ATTACHMENT 1

TECHNICAL SPECIFICATION 3.6.3

CONTAINMENT ISOLATION VALVES

DIABLO CANYON - UNIT 1
3/4 6-1B

FIGURE 6.2-1

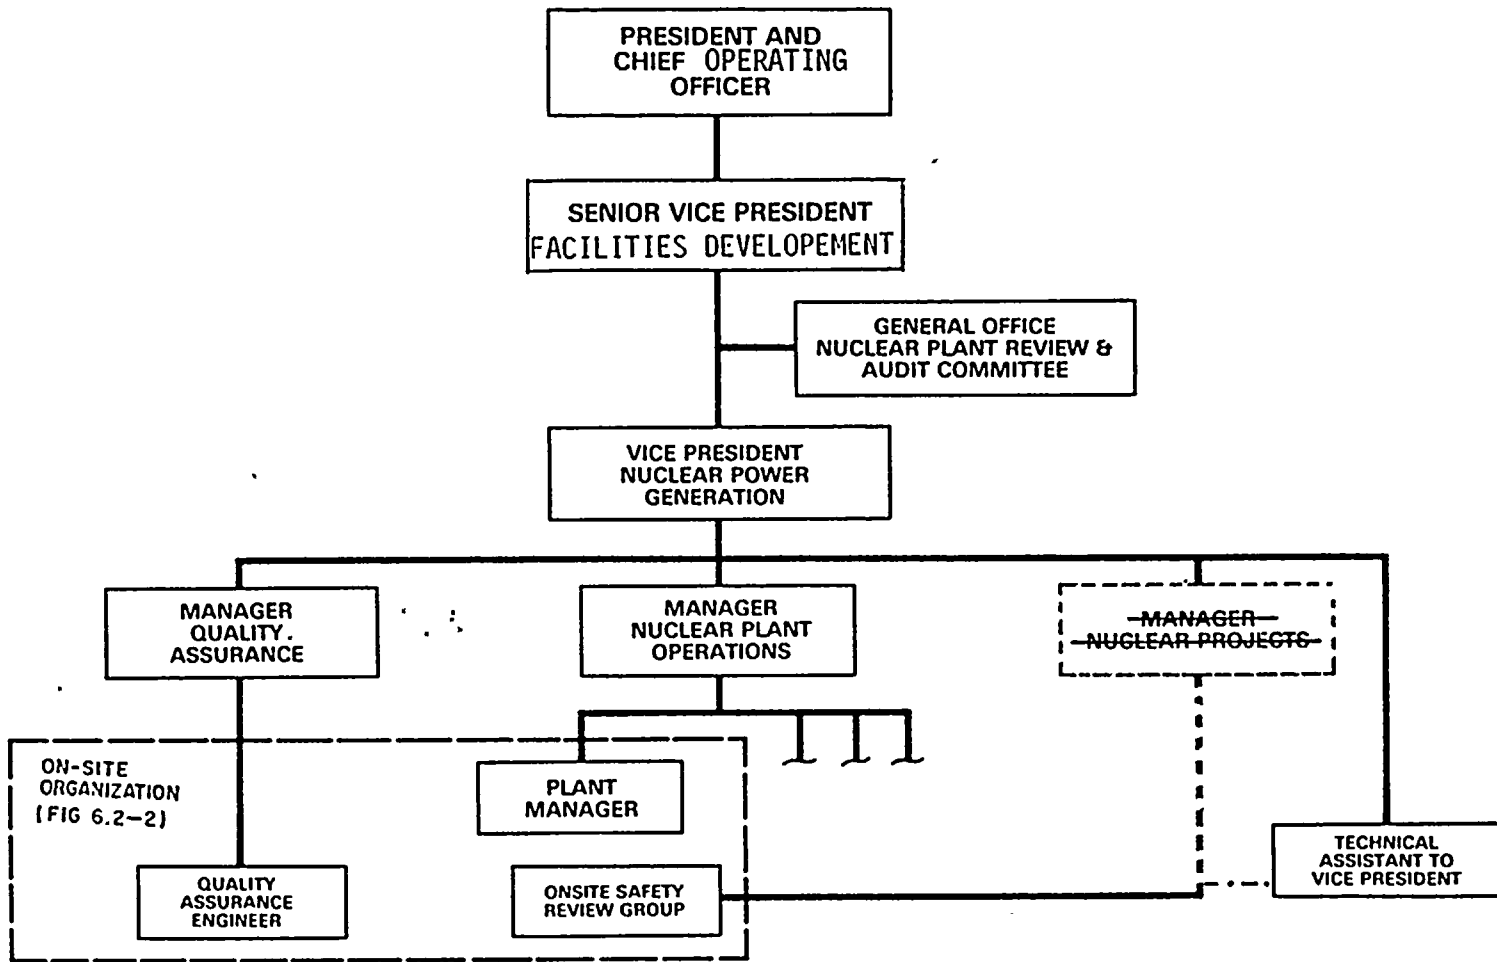
The Senior Vice President, Facilities Development, reports to the President and Chief Operating Officer. The General Operating Foreman reports directly to the Supervisor of Operations and the position of Manager, Nuclear Projects is deleted from the Technical Specifications. The Technical Assistant to the Vice President Nuclear Power Generation assumes the responsibility of interfacing with the Onsite Safety Review Group in place of the Manager, Nuclear Projects. The changes discussed above are shown in the attached pages 6-2, 6-3, 6-5 and 6-8 of the Technical Specifications.

The responsibilities relating to the Onsite Safety Review Group will be transferred to the Technical Assistant to the Vice President, Nuclear Power Generation. In particular, he will review the recommendations of the Onsite Safety Review Group for revised procedures, equipment modifications, maintenance activities, operations activities or other means of improving unit safety.

FIGURE 6.2-2
FACILITY ORGANIZATION
DIABLO CANYON POWER PLANT

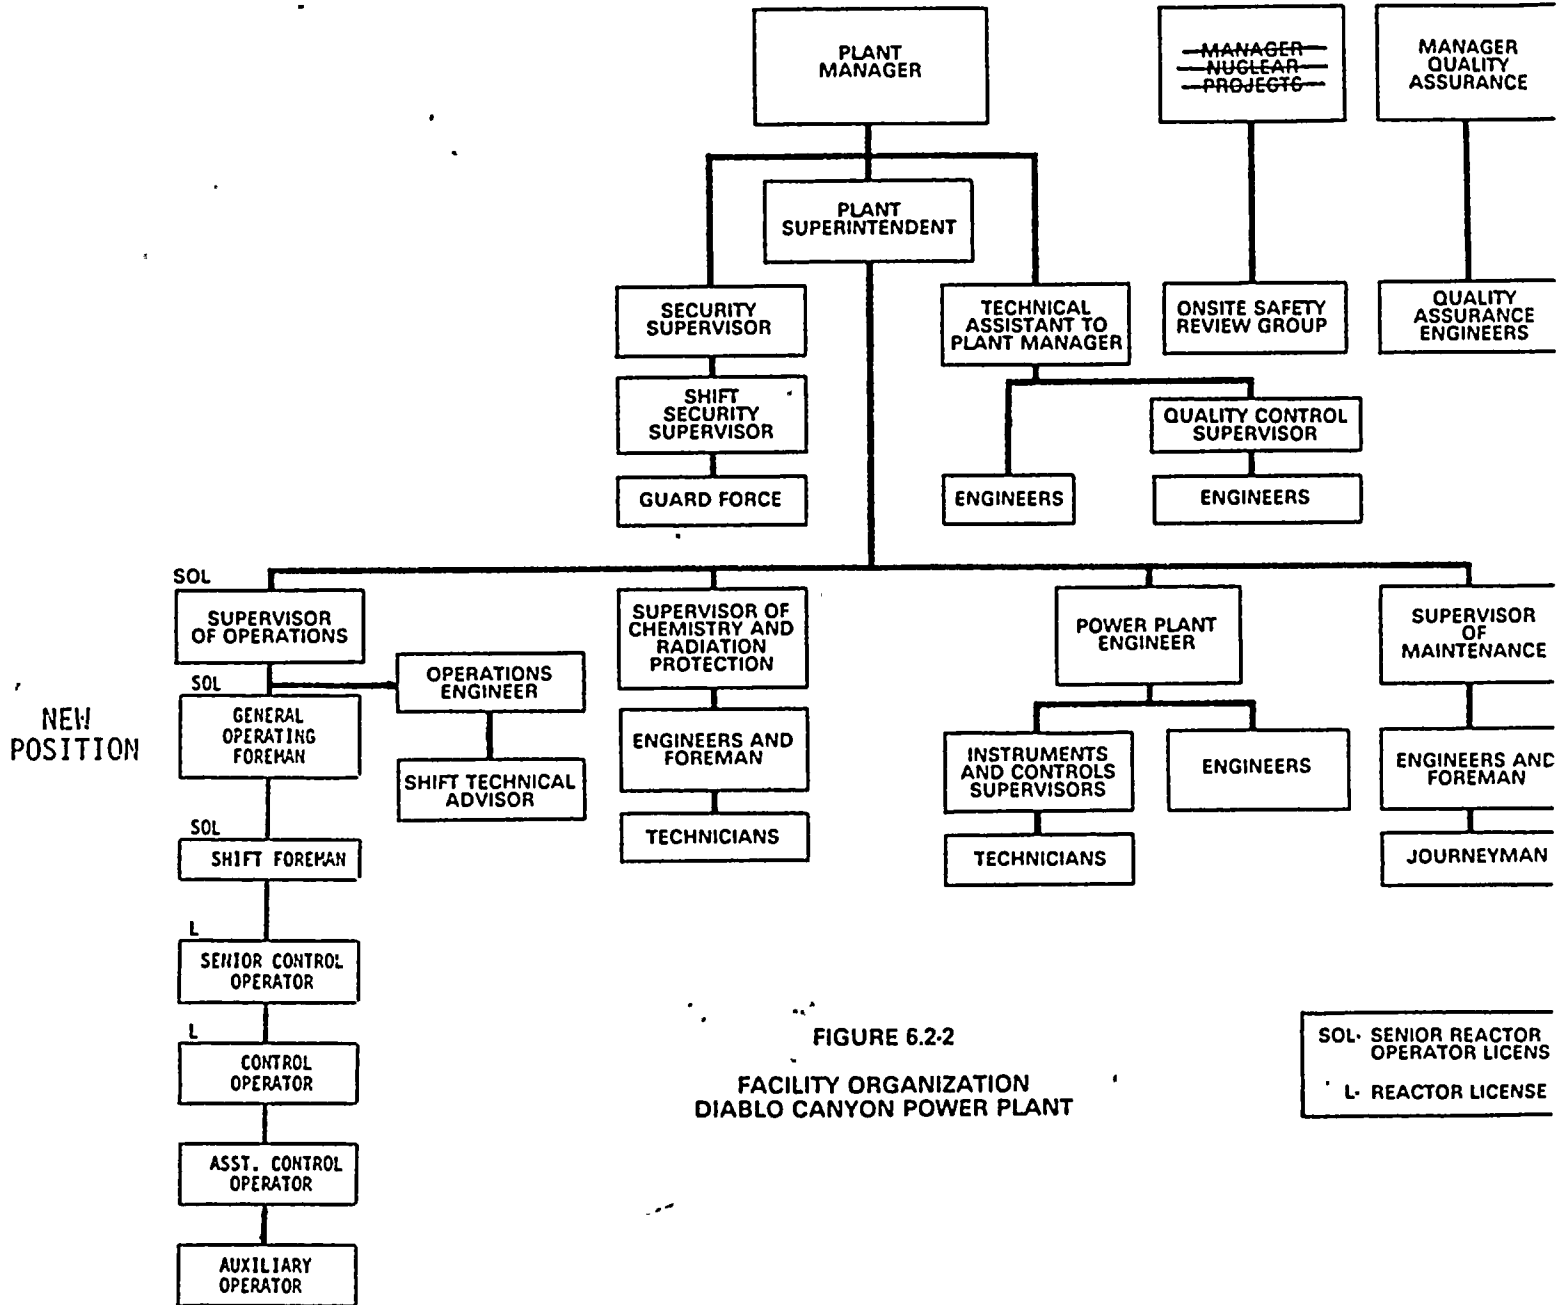
The facility organization for DCPD shows (1) the Senior Vice President, Facilities Development, reporting to the President and Chief Executive Officer, (2) the Shift Foreman reporting directly to the Supervisor of Operations and (3) the Onsite Safety Review Group makes recommendations to the Manager, Nuclear Projects.

The change from President and Chief Executive Officer to President and Chief Operating Officer is to correct a typographic error. The General Operating Foreman will supplement the Supervisor of Operations in his duties. He will not assume any authority of the Supervisor of Operations nor his responsibilities unless delegated. This change allows the overall facility organization to maintain a better and closer control of the operators and will provide quicker response to operator questions and problems.
